Agenda item	6.9
Report no	PLN/023/19

THE HIGHLAND COUNCIL

Committee: North Planning Applications Committee

Report Title: 18/05061/FUL - Land 50M West of Windygates, Newton Row Wick

LOCATION PLAN

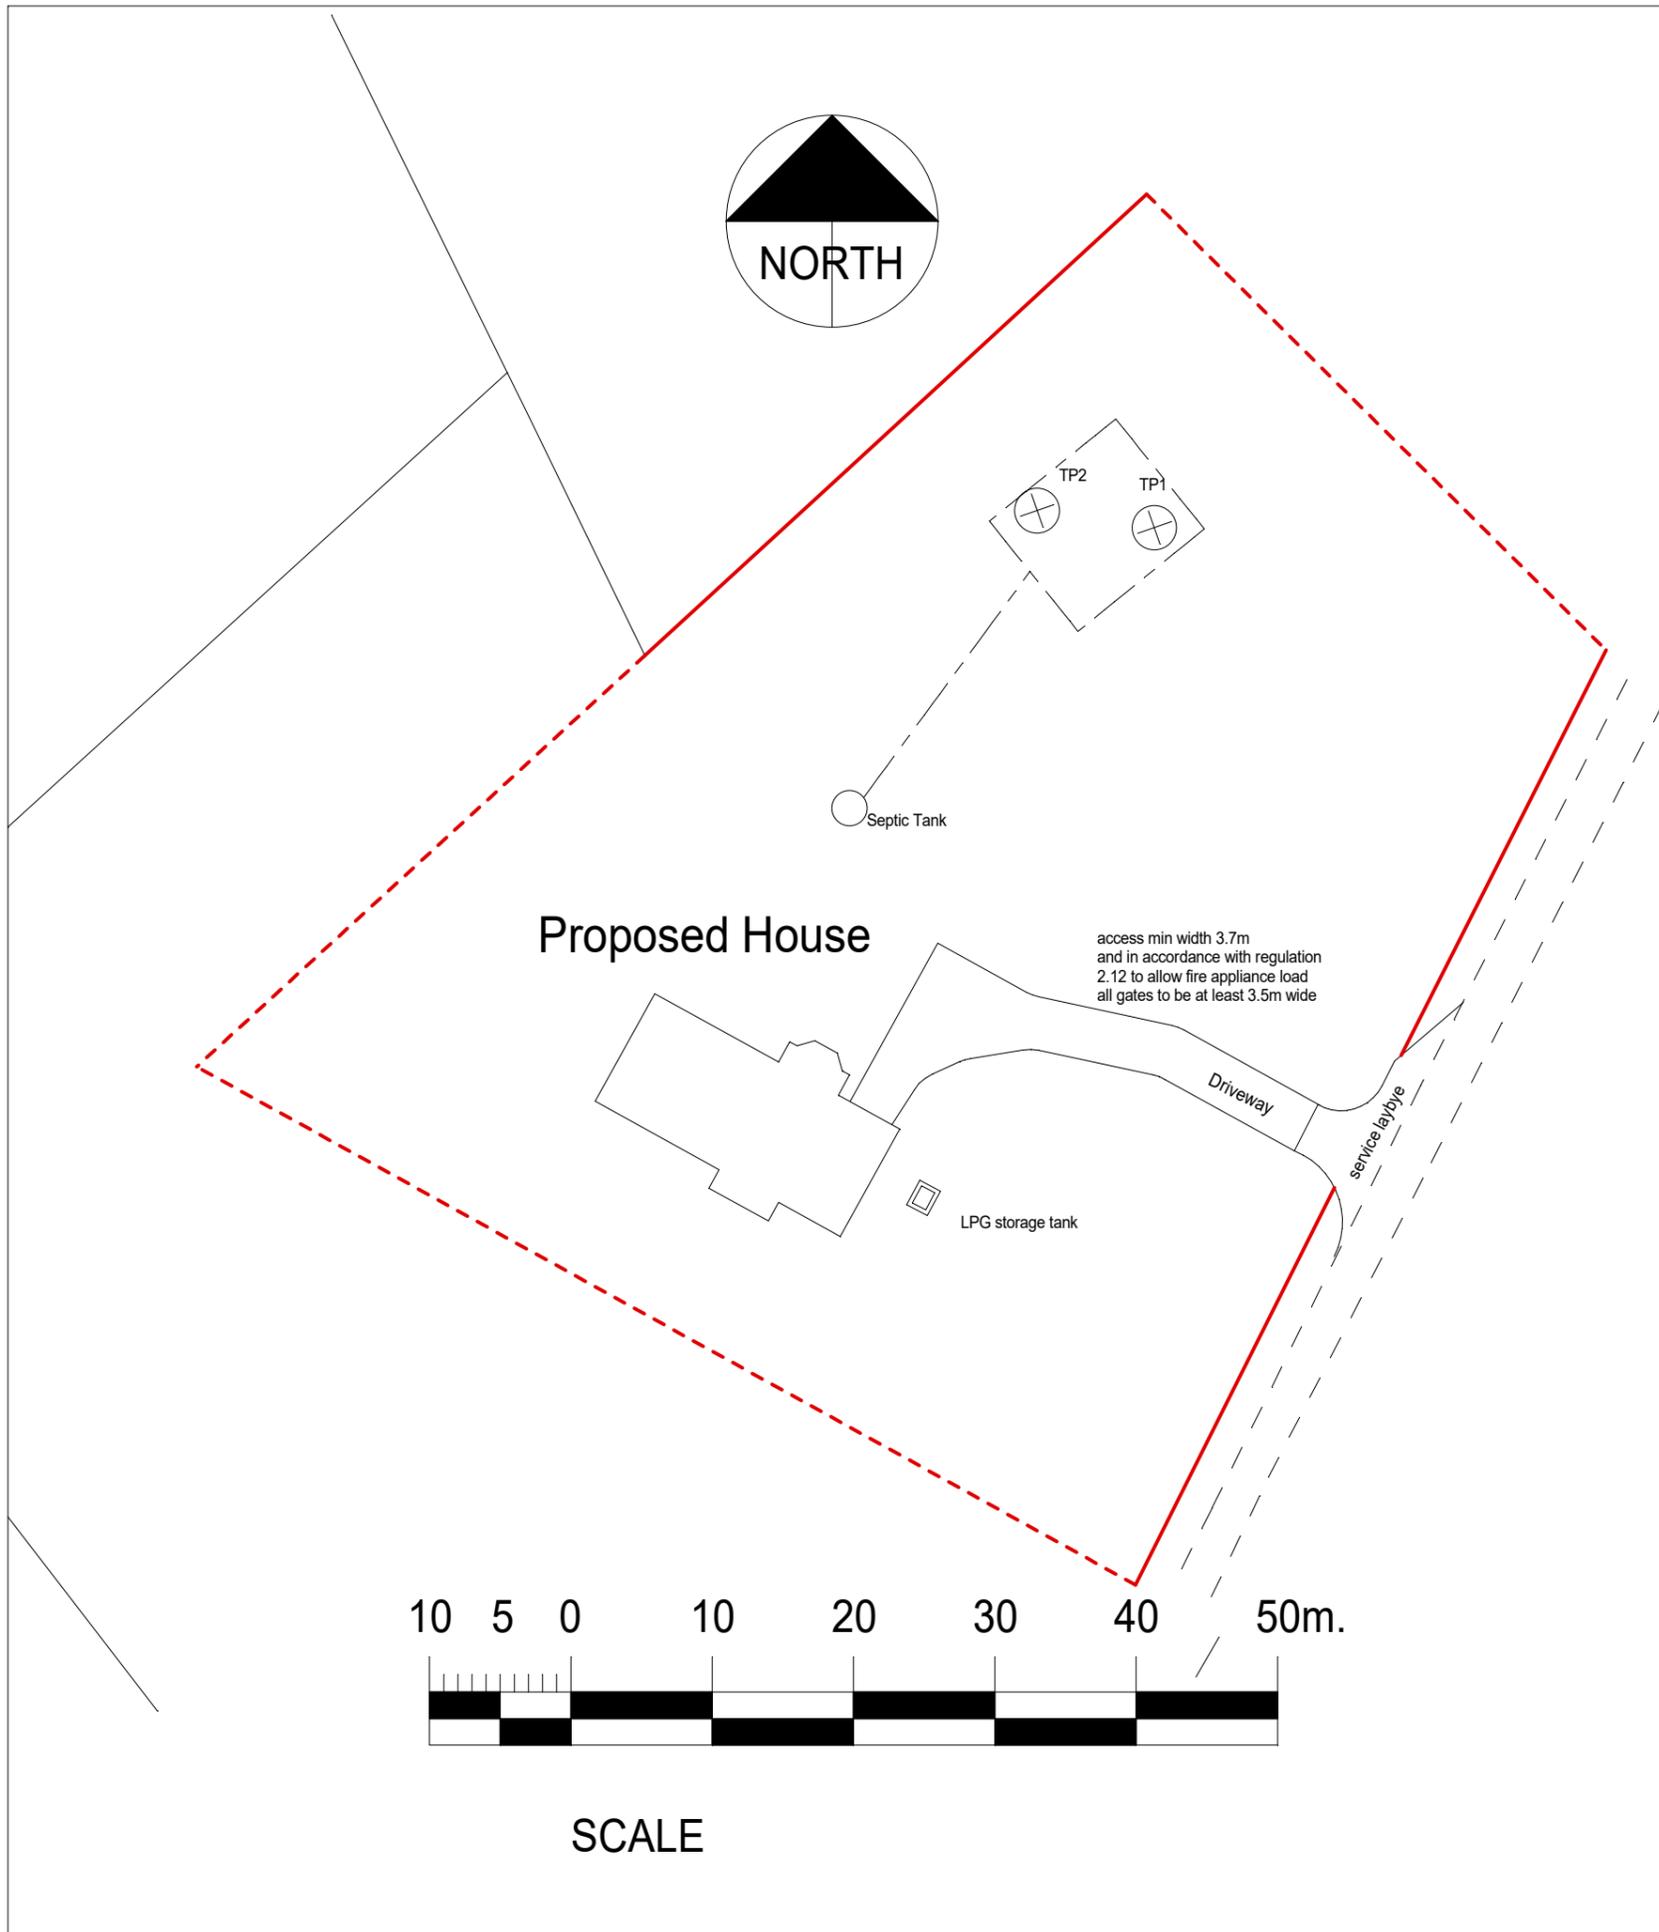
1. An extended layby at the proposed access to provide both a service layby and a passing place / or an additional passing place on the plot frontage in addition to the service bay.

2. The plot boundary should be set back to permit widening of the carriageway to 5.5m and a 2m verge if there is future cumulative development along the west side of the U1241. (The current plan also shows no verge behind the service layby – a 2m verge should be provided).

- 10.6 Determination of the application has been hampered by confusion around the extent of the applicant's landownership and following a lengthy delay, a revised plan was submitted on 7th January 2019 which provides an accurate site ownership boundary. This indicates that much of the surrounding land is within the control of the applicant including the area around the existing house to the north, Gilvoan. It was suggested to the applicant that there may be scope for development of a house in this location, which would benefit from being able to share the existing access serving this property. This would firstly allow the proposed house to relate to existing development as well as reducing development pressure on the unclassified Newton hill road. The applicant has regrettably chosen not to pursue any alternate options. For the avoidance of doubt, any revised siting would require submission of a fresh application.

- 10.8 As noted by Transport Planning, the unclassified road leading to the site is in poor condition with limited passing places relative to the number of houses which it currently serves. As such, Transport Planning have outlined a number of requirements including provision of an extended layby on the plot frontage to provide a passing place in addition to a service bay, and the upgrading of an existing passing place to the east of the site. In addition the plot boundary should be set back to permit widening of the carriageway in the event further development takes place along the west side of the road. Whilst Transport Planning have not objected, the specified road improvements are required to make the proposal acceptable. The use of a shared access is given preference in the Council's Access to Single Houses and Small Housing Developments. Should an alternate site be pursued as described in Section 8.8, this would negate the need to such improvements through the shared use of an existing access.

DRAWN	DATE	SCALE	
	Oct 2018	1/100	
Mr & Mrs Harper Langley House 35 Thurso Road Wick, KW1 5LE			
TITLE Erection of house at Land Newtonhill Wick Elevations			
REV.		DRW.NO.	CH/3
DATE

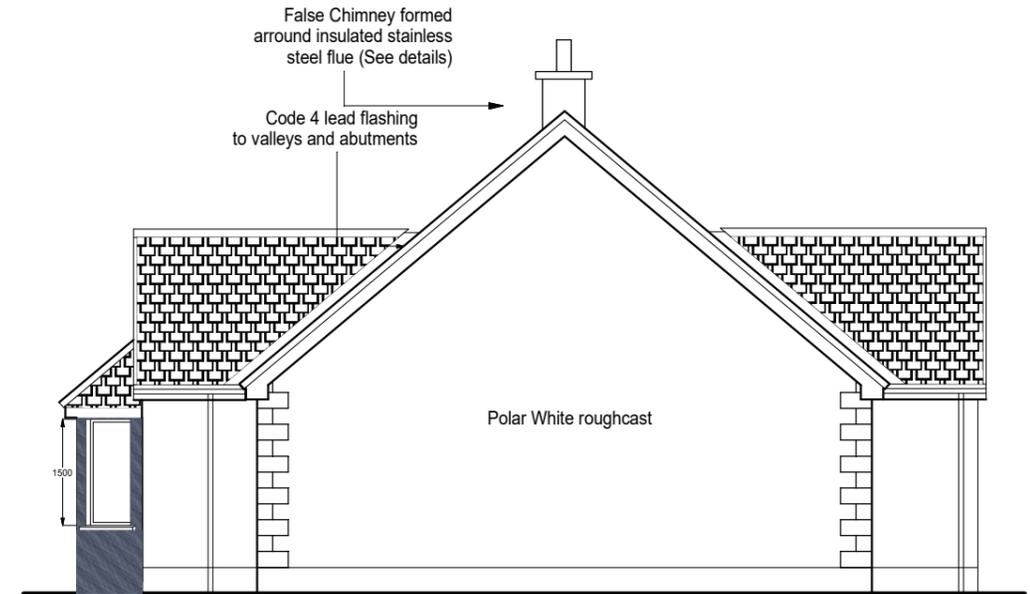
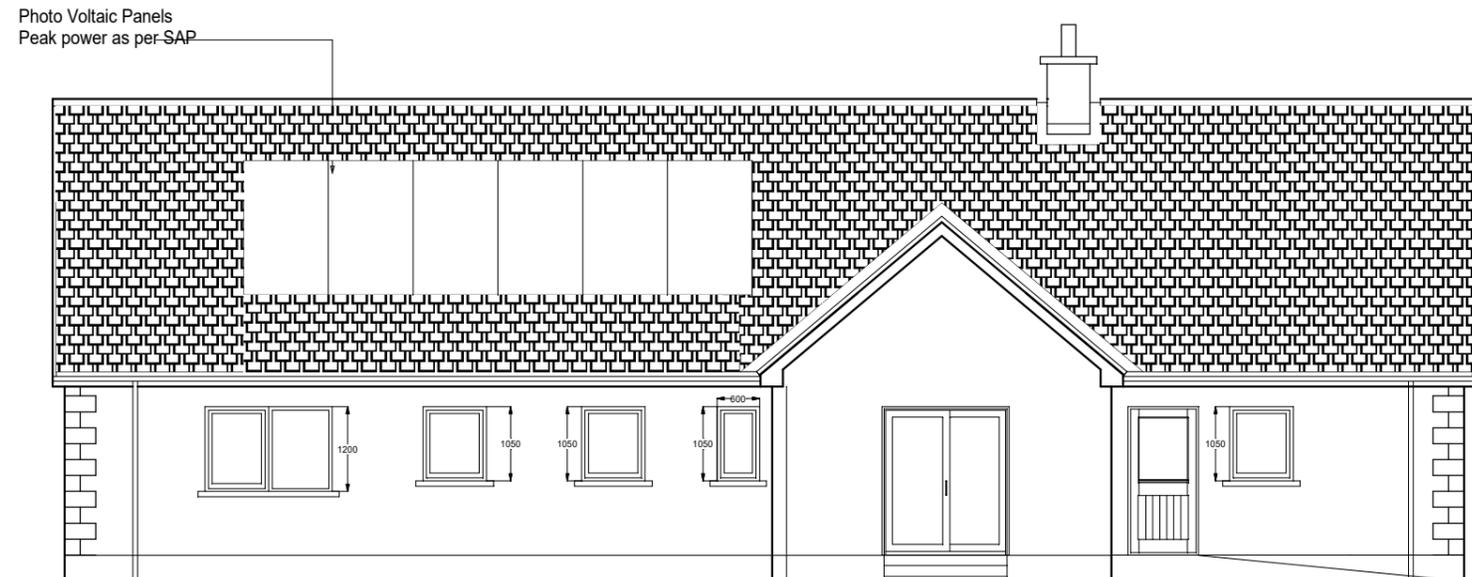
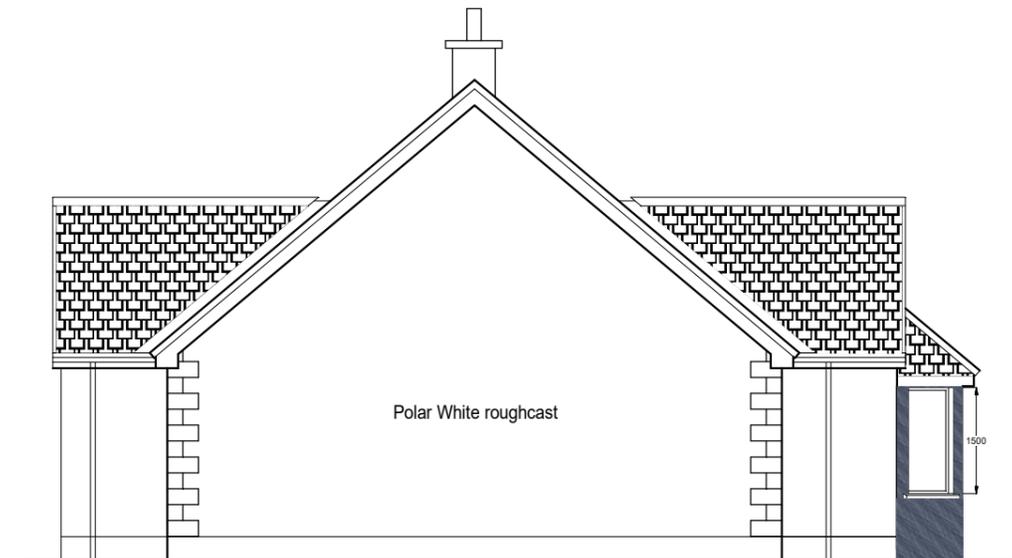
- 10.7 The proposed design is a bungalow with a large footprint and an appearance more akin to a suburban dwelling rather than a house in a countryside location. Whilst the houses to the east of the public road comprise of a mix of designs, the proposal does not possess the appearance of a traditional rural house however also fails to present an innovative or contemporary design. The Planning Authority has been proactively seeking to improve the quality of rural design in Caithness and it is not considered that the proposed house would benefit from some re-design in order to comply with the design criteria outlined in the Housing in the Countryside and Siting and Design SG, for example the overall mass could be broken up through use of an L or T shape footprint, windows could be altered to present more of a vertical emphasis which would allow the house to have proportions and detailing more commensurate with its rural location.
